SERVICE BULLETIN

Date:	03/22/2024		
Document Number:	TM-VPK-010		
BULLETIN TYPE:	Internal and External	Subject:	Indoor Motor Wiring
PRODUCTS AFFECTED:	VHA18-RTQ	Author:	Technical Management

Vert-I-Pak 18 Motor Rewire

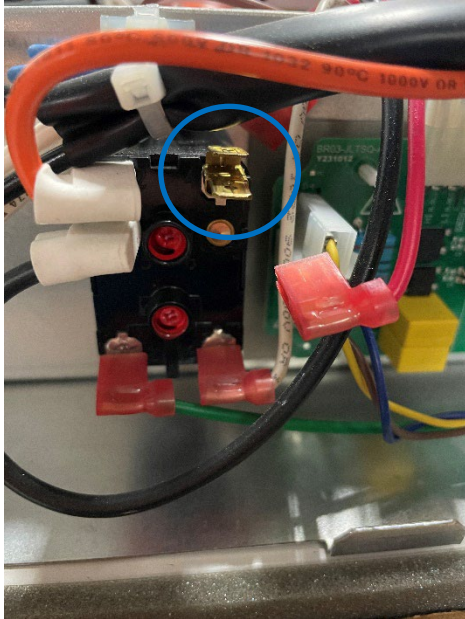
- Cut wire tie to free the L1 (Black) wire off the small blower control board. Remove the wire from the contactor pole.

Disconnect the black wire from the contactor

- Disconnect the red speed wire of the small blower control board from the top right corner of the speed relay to the direct left of the blower control board.

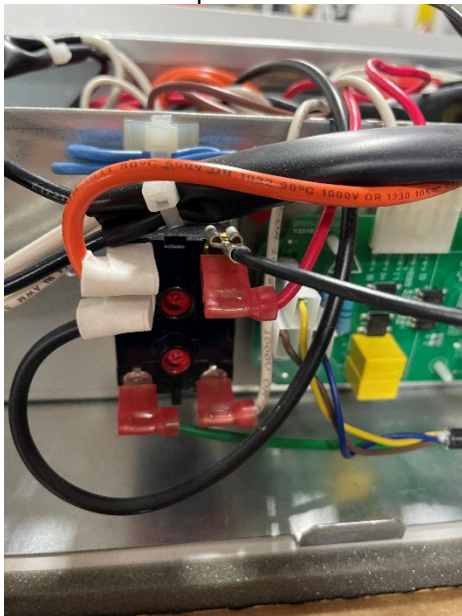
- c) Add the piggyback terminal splitter to the top right corner of the speed relay (Note: If the speed relay has a white jumper wire connected to that terminal, the white jumper wire should stay in place).

- d) Reconnect the speed wire and black wire to the two terminals on the piggyback terminal splitter
